South Australian Energy Transformation

**Determination on dispute -
application of the regulatory
investment test for transmission**

June 2019

Figure 1: Concept design of the SPS

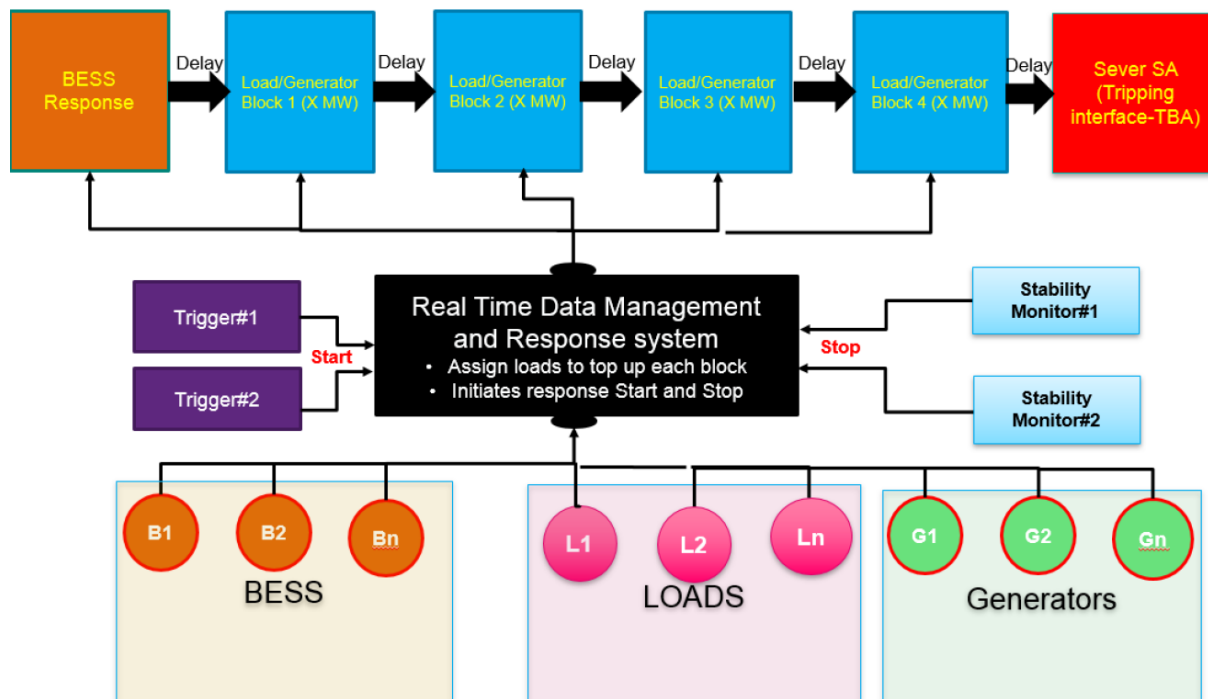
ElectraNet provided further details in support of the concept design (refer to Figure 1).

Specifically, in response to our 2 April information request, ElectraNet initially advised that the key features of the SPS include the following:⁴¹

- Real time monitoring of load and battery storage to determine the available response at any given time. Response options include load shedding in pre-defined blocks and BESS (grid scale battery) supply. BESS responses will be prioritised over load shedding.
- Monitoring of system stability to determine when to stop the load shedding/generation tripping after the system returns to a secure state.

This information is limited in that the principles of the design concept for an SPS are not sufficient to demonstrate the high likelihood that the SPS could be implemented as intended.

In consequence, we sought further information to clarify whether feasibility studies, including response timeframes for operation of the SPS, had been undertaken.

ElectraNet subsequently provided clarification on the system security concerns raised by SACOSS and, in particular, the technical feasibility of an SPS for the preferred option in the SAET RIT-T⁴²:

- ElectraNet states that power system studies have been undertaken for various conditions to test the operation of the SPS and ensure the South Australian power system remains connected securely with the NEM, without causing any other technical issues which may put system security at risk.⁴³ Specifically, ElectraNet advises that all simulation studies undertaken to date have indicated that the system is secure following the SPS action and that all system technical parameters are within limits.

- This was evidenced in ElectraNet's follow up response which provided study outcomes from feasibility studies that ElectraNet conducted in the PSS/E simulation environment.⁴⁴ ElectraNet advises that these studies assumed load shedding of 400 MW. The studies also assume BESS response of 100 MW from the loss of either interconnector under maximum combined interconnector import conditions into South Australia, and 500 MW of generation tripping while exporting from South Australia.

- ElectraNet advises that these feasibility studies have used an SPS response time of 370ms from fault inception. ElectraNet also advises this response time will be optimised during detailed design and implementation of the SPS. AEMO considers that the 'control action timings' assumed for the proposed SPS are realistic and achievable.⁴⁵

The technical feasibility of the proposed SPS is supported by AEMO. AEMO states that detailed feasibility studies have demonstrated the capability of an SPS to achieve interconnector transfer levels as outlined in the SAET RIT-T.⁴⁸ AEMO concludes that:⁴⁹
